APPROVED
 Limited building only review
 Permit holder responsible for full compliance with the code

THE
 KATHRYN
 LOT 18 PRINCE PLACE

TRIPLE A HOMES	
SCOPE	STRUCTURAL ADDENDUM
LOC	18 PRINCE PLACE
PLAN	KATHRYN
REV 1	RJS 10-13-2021

SECOND FLOOR PLAN
SCALE: 1/8" = 1'-0"

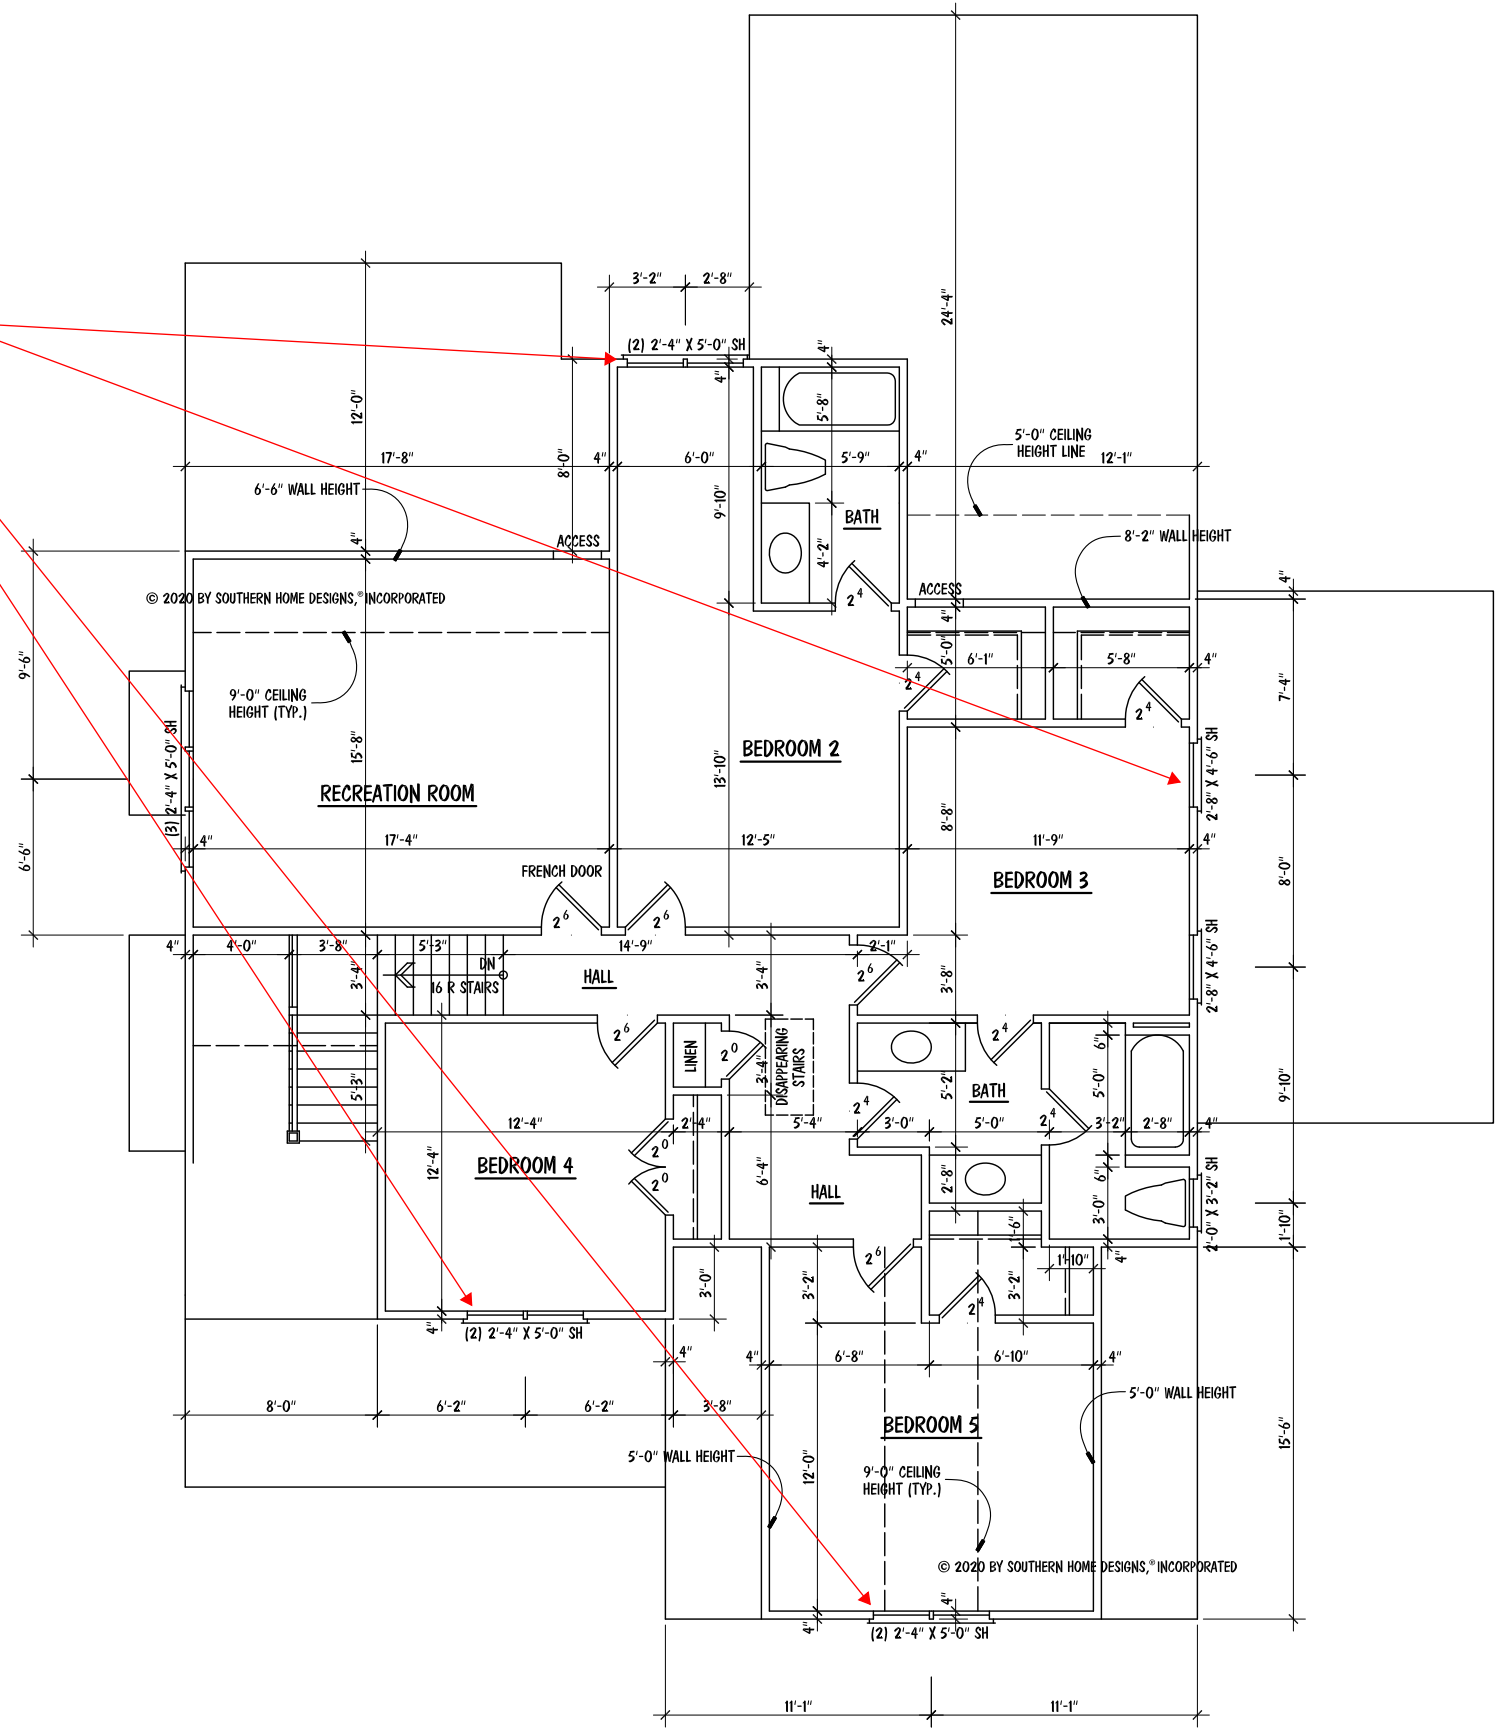
Field Verify Egress
